Item 5.**Development Application: 905 South Dowling Street, Zetland - D/2024/1029****File Number:** D/2024/1029**Summary**

Date of Submission: 18 November 2024. Amended drawings and additional information were submitted on 19 March 2025.

Proposal Summary: Approval is sought for a mixed-use development on the Stage 2 North-Western (NW) portion of the broader Suttons redevelopment site comprising:

Figure 20: Building separation between Buildings A and E

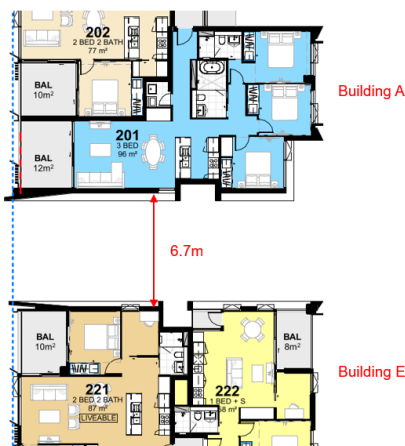
6.7m separation is provided between habitable rooms, whereas the ADG recommends 12m up to 4 storeys and 18m up to 8 storeys.

A condition is recommended requiring the south facing living room windows on Building A to be treated with obscure glazing.

Figure 21: Building separation between Buildings G and H

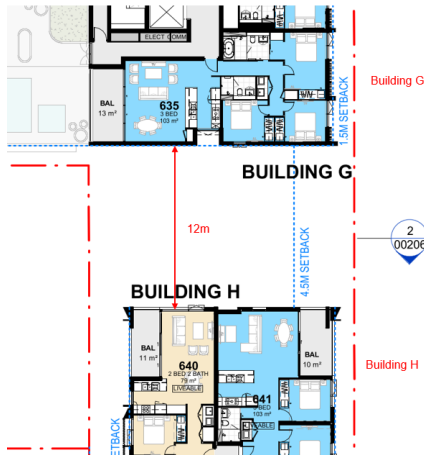
12m separation is provided between habitable rooms, whereas the ADG recommends a minimum of 18m above 4 storeys.

A condition is recommended requiring the south facing windows of Building G to include fixed vertical privacy louvres angled to the south-east.

Figure 23: Building separation between Building E and 8-12 Peters Street

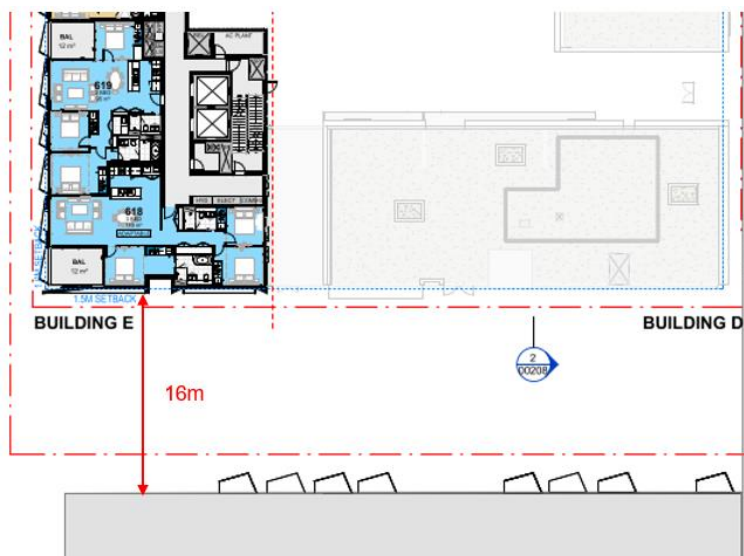
A building separation of 16m is proposed. The ADG recommends 18m building separation above Level 4 between habitable rooms / balconies.

A condition is recommended that requires the south facing balconies and bedroom windows on Building E from Level 4 and above to include fixed external privacy louvres.

Figure 24: Materials and finishes schedule proposed in the competitive design process

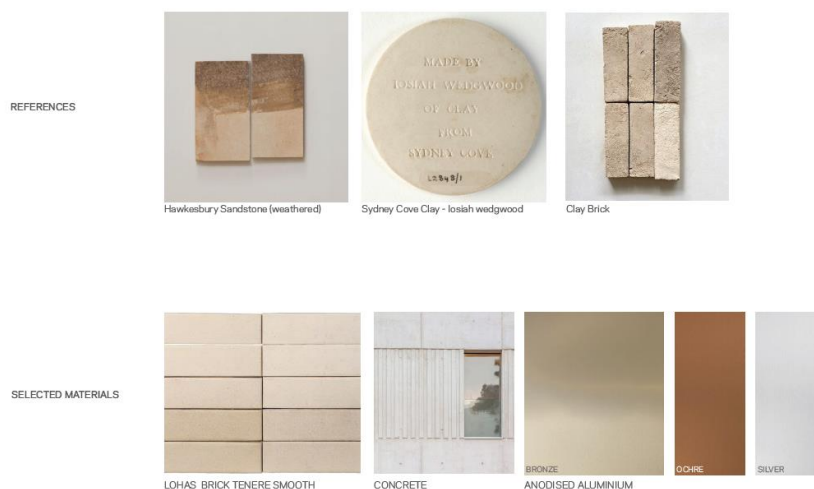
95. The scheme submitted as part of the competitive design process featured high quality materials and finishes, including the use of brick across all buildings in 'Lohas Brick Tenere Smooth'.
96. The approach to materiality was identified by the Selection Panel as a strong element of the scheme to be retained during design development.

97. The materials and finishes schedule submitted with the DA was more generic in comparison, proposing painted precast concrete, no brick specification and grey tinted glazing.
98. The Design Advisory Panel considered the high quality materials to be important to the building's architectural simplicity and did not support a reduction in material quality from the design competition scheme.
99. Council's Request for Information therefore requested a revised materials and finishes schedule that included a high quality face brick specification (not precast with a brick pattern or brick snaps in precast) and clear non-tinted glazing to windows and balustrades.

Figure 26: Extract from the Pedestrian Wind Assessment showing the recommended screen at the Building E lobby entrance

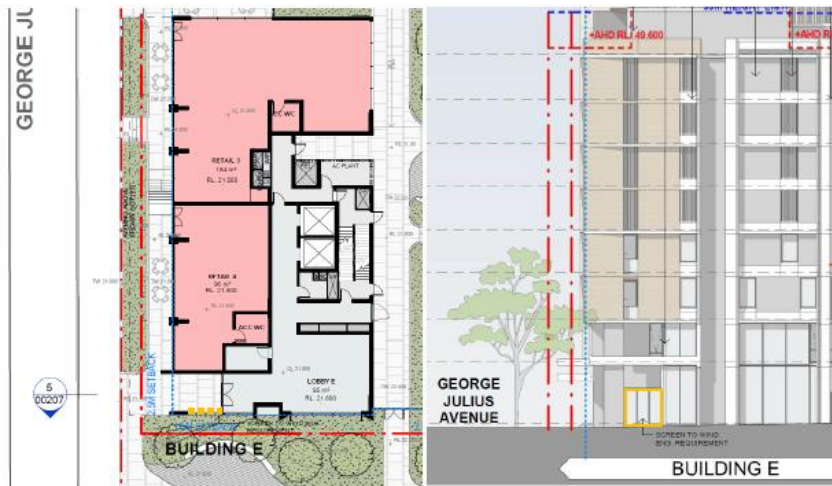
- (b) Location 4 (south-western corner of Building E on the ground floor) fails the safety criteria. The wind report recommends a screen in this location, south of the lobby entrance. This has been included in the recommended condition.

Figure 28: Proposed ground floor loading dock

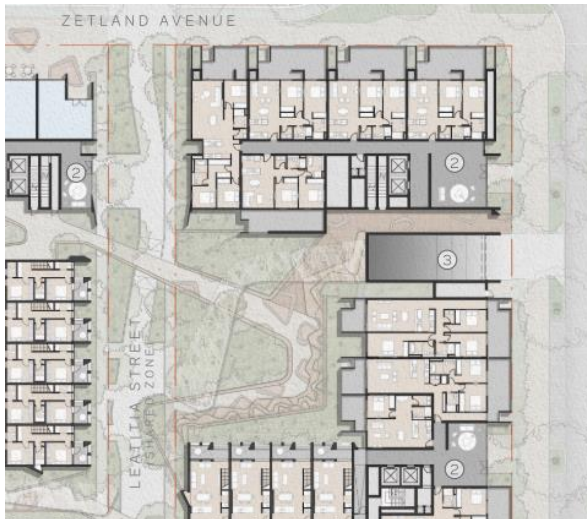
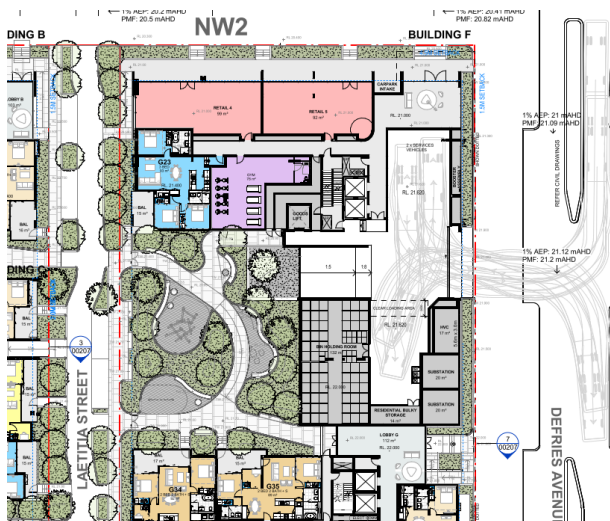
- 107. The scheme submitted as part of the competitive design process proposed all servicing to be undertaken within the basement. Vehicle and servicing access was provided from Defries Avenue in Building F, with a single ramp down to the basement as shown in Figure 27 below.
- 108. The Selection Panel supported this arrangement and recommended the retention of basement efficiency and the loading dock configuration throughout design development.

109. The application now proposes a ground floor loading dock co-located with a ramp down to the basement, as shown in Figure 28 below.

110. Changes have been made to the proposed ground floor loading dock throughout the assessment to address issues relating to the size and location of the bin storage rooms and the co-location of car access and service vehicle access.
111. The amended loading dock design is generally supported. The applicant has submitted swept paths to demonstrate that Council's 10.6m waste vehicle can enter forward into the northern dock and reverse back into the southern dock for waste collection, followed by reversing out of the site in a forward motion.
112. However, conditions of consent are recommended to ensure potential conflicts between service vehicles using the loading dock, vehicles entering/ exiting the basement and pedestrians are avoided to ensure safety.
